FIELD INSPECTION REPORT

Project Name:	Mountain Valley Pipeline	Inspector:	Matthew Grant
Inspection Date:	Tuesday, April 12, 2022	Project Contact:	Brian Clauto
Spread H: Montgomery	St12544+16-12450 ATWS 645A AR-MN278.01	Weather:	Dry

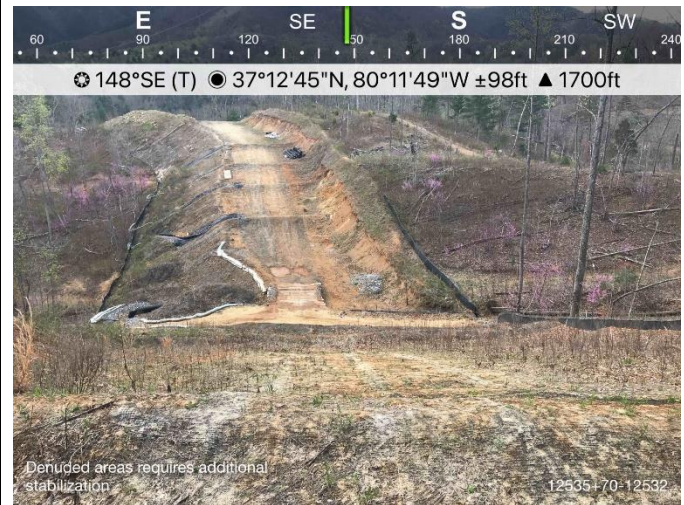
- Figure 1: Additional stabilization required near stations 12535+70-12532.

- Figure 2: Additional stabilization required near stations 12535+70-12532.

- Figure 3: Above designated crossing S-EF19, ECD's are in place and functioning.

- Figure 4: St 12485, ECD's are in place and functioning.

Recommended Corrective Action: Maintain and install all controls per the approved PSS&S.
